SAFETY INSPECTION REPORT OF LAKE GENEVA DAM ID #617

Prepared for:
LAKE GENEVA ASSOCIATION
1114 E. Geneva Drive
City of DeWitt, MI

Inspection Dates: Dec 19, 2011 & March 27, 2012

Report Date: May 2012

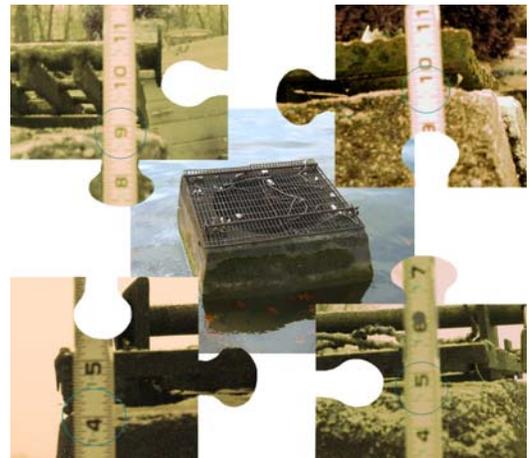
within the top surface of the dam as shown in the picture to the left.

1. Check for burrowing animals and remove if present. Fill and compact any damaged areas by the animals. **Moles seem to be present**

2. Remove and dispose of all tree leaves away from the discharge pipe along the downstream end. Keep grass clippings and leaves to the west end along the widest

point of the dam. This will discourage animals from using the dam as a shelter and provide for better visual inspection of the dam condition
